## MPC8306 Chip Errata

This document details all known silicon errata for the MPC8306. The following table provides a revision history for this document.

**Figure 1. Recommended connections for DDR controller and memory**

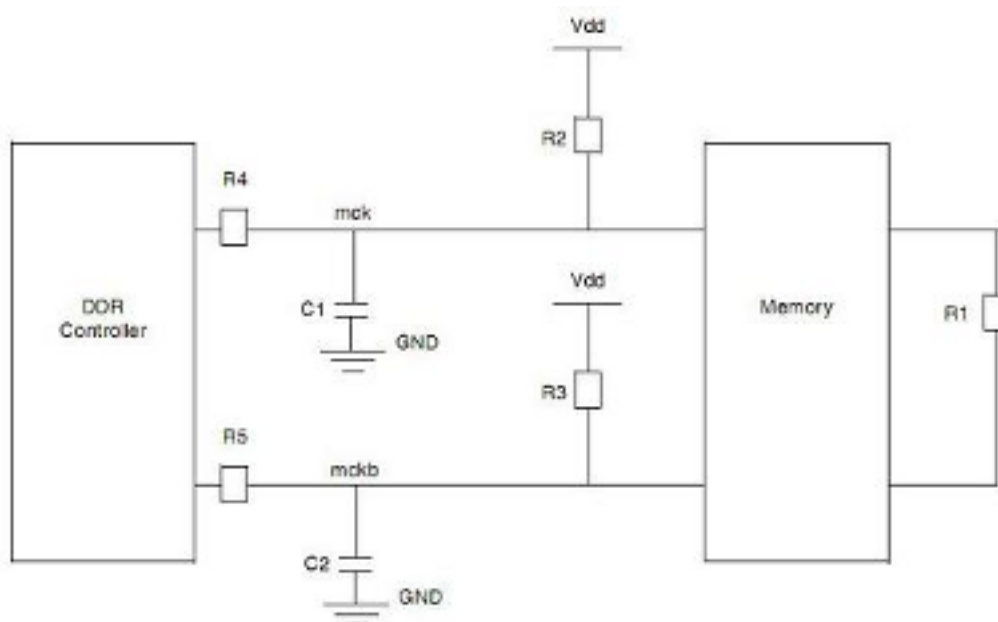
## DDR21: MCK/ $\overline{\text{MCK}}$ AC differential crosspoint voltage outside JEDEC specifications

**Description:** The crossover points of the MCK and  $\overline{\text{MCK}}$  signals of the DDR controller are not meeting JESD79-2C specifications, which indicates that the crossover points should lie within  $\pm 125$  mV range of reference voltage.

**Impact:** Disagreement with the JESD79-2C standard.

**Workaround:** To meet the JESD79-2C crosspoint voltage specifications, we recommend implementing the following connections between the DDR controller and DDR2 memory:

1. Increasing R2 and R3 shifts signal levels up (used as pull up).
2. Increasing C1 increases rise/fall time of mck signal.
3. Increasing C2 increases rise/fall time of mckb signal.
4. Reducing R1 can help in shifting the signals up.
5. R4 and R5 can be used to make termination proper.

R4, R5, C1, C2 near to SOC, R1, R2, and R3 have been placed at the end of clock transmission lines.

We recommend varying termination resistor R1 first. Lowering R1 can help increase the voltage levels up. The only disadvantage is that it may add up more reflections. Therefore, the user must decide accordingly. If it does not give sufficient margin, the user can add the pull-up resistor (R3 and R4) option to further increase the voltage levels.
